# SERVICE BULLETIN

No. 415

Piper Aircraft Corporation

Subject: MAA Plate Replacement and Tailpipe Gasket Installation

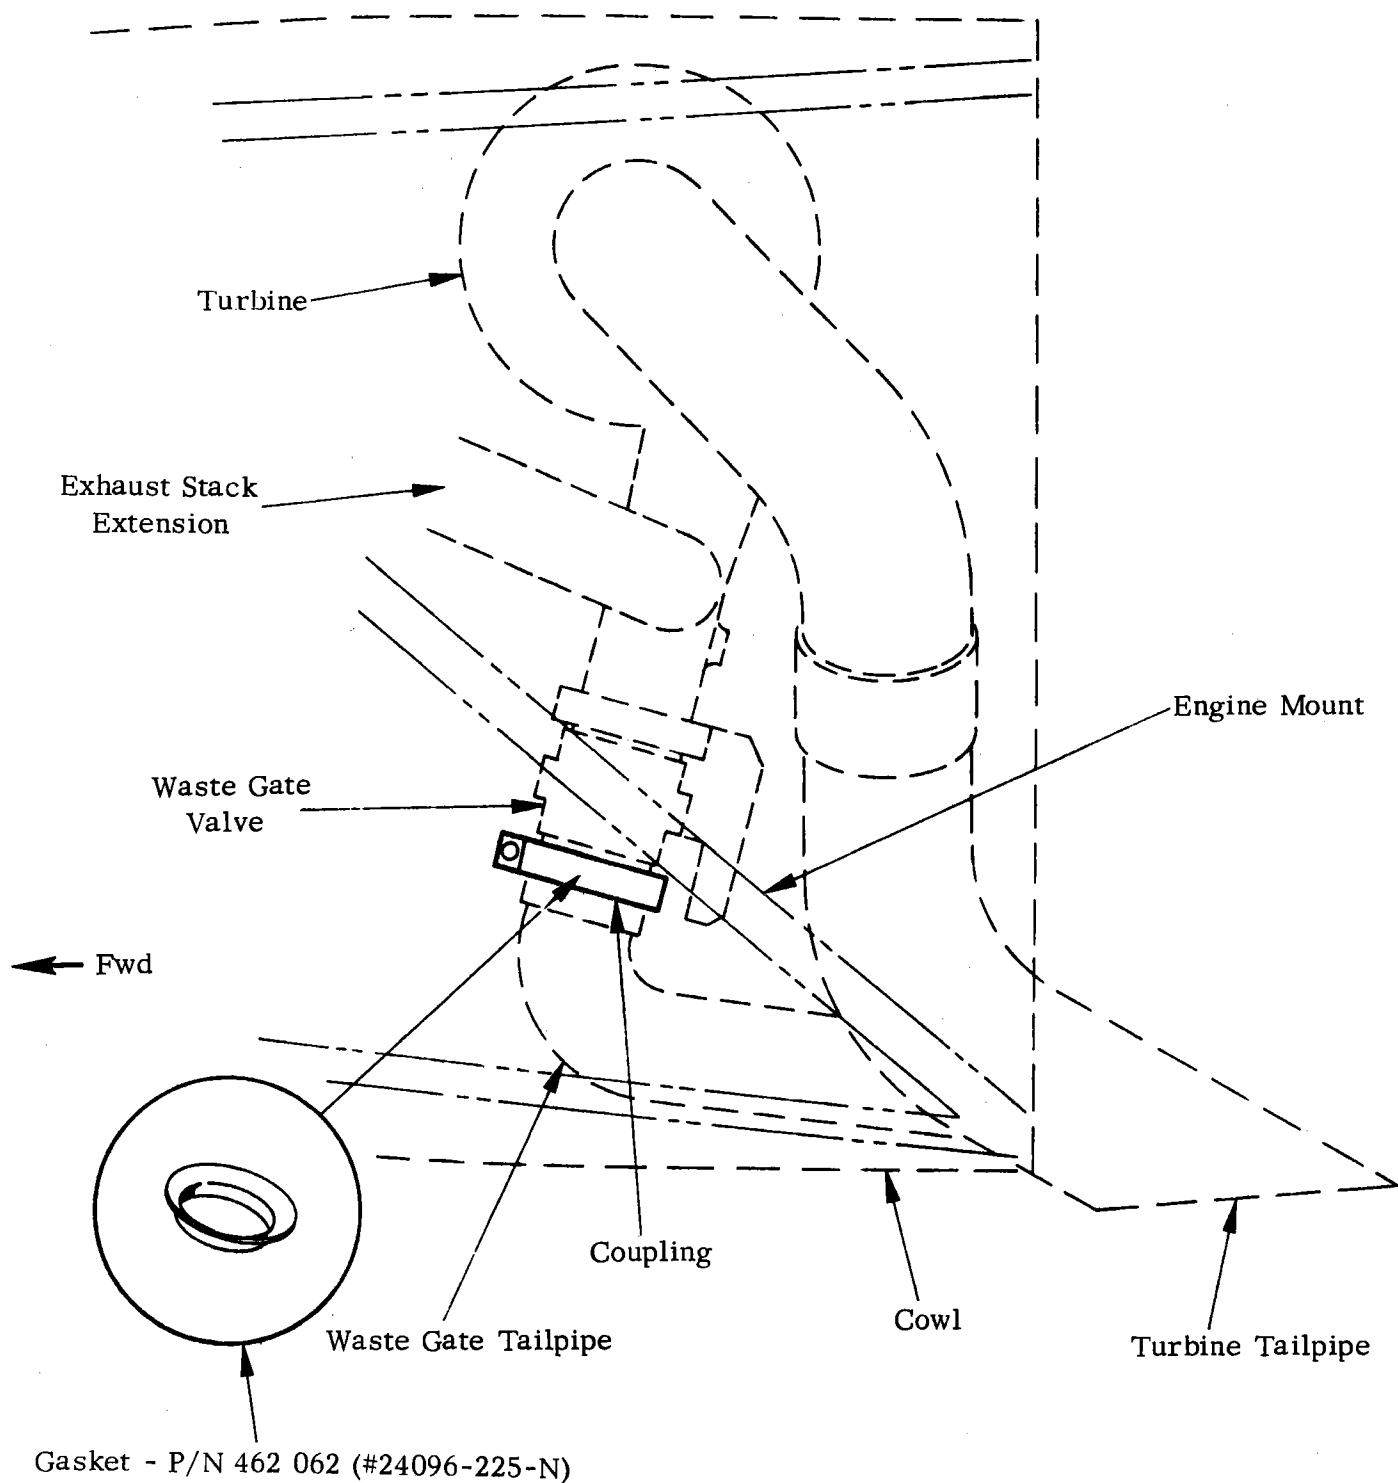
1. Inspect waste gate valve/tailpipe area on both engines to determine whether gasket, Piper Part No. 462 062 (24096-225-N), is properly installed. Refer to attached sketch/instruction sheet for location and installation details.
2. If gaskets are installed, make appropriate log book entry; no further action is required.
3. If gaskets are not properly installed, install per attached sketch/instruction sheet.
4. Make appropriate log book entry.

1. Disconnect the coupling that attaches the tailpipe to the waste gate valve.
2. Install gasket, P/N 462 062, between the tailpipe and waste gate valve and reinstall coupling.
